Contract #: 04-0120F4Cty: SF/ALA Rte: 80 PM: 13.2/13.9File #: 69.25B**QUALITY ASSURANCE -- NON-CONFORMANCE REPORT****Location:** Changxing Island, Shanghai, China**Report No:** NCR-000780**Prime Contractor:** American Bridge/Fluor Enterprises, a JV**Date:** 29-Jun-2010**Submitting Contractor:** Zhenhua Port Machinery Company, Ltd (ZPMC), Changxing Island**NCR #:** ZPMC-0742**Type of problem:**

Reference Description: Missed UT Indication Discovered by QA**Description of Non-Conformance:**

Subject: NCR No. ZPMC-0742

项目名称 Project Name	美国海湾大桥 SFOBB	部件图号 Drawing No	SSD19A	报告编号 Report No.	B-WR13892
合同号 Contract No.	04-0120F4	部件名称 Items Name	11AE PLATE PANEL SPLICE	NDT报告编号 Report No.of NDT	B787-UT-13669
项目编号 Project No.:	ZP06-787

WELD NUMBER: SSD19A-PP96-128

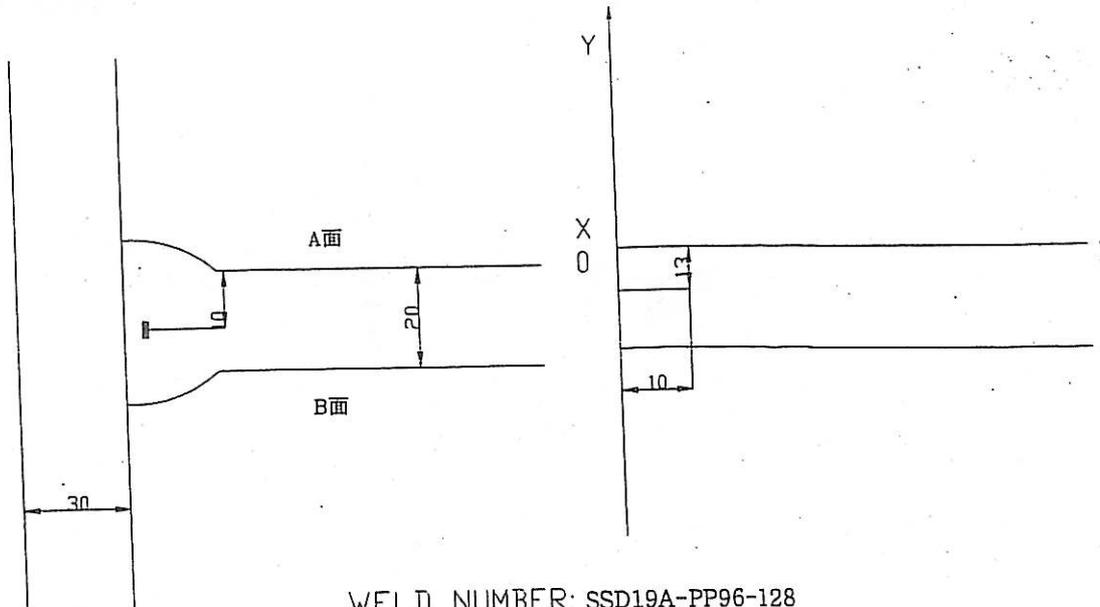
Description of welding discontinuity:

Rejected indication found by ultrasonic inspection is less than the maximum allowance aggregate length.

Caused:

1. Did not clear the weld pass completely in time.

1. Gouge or grind from nearer side from metal edge ($D \leq 0.65T$, "D" is depth of defects, "T" is thickness of metal) to remove all defects;

2. Follow repair WPS for joint preparation, preheat, and weld deposit;

3. Verify with VT no defects remain in the weld joint prior to welding;

4. Grind the repaired area flush with base metal or the adjacent weld;

5. Perform UT inspection to the weld along with 50mm on each end of the repair area;
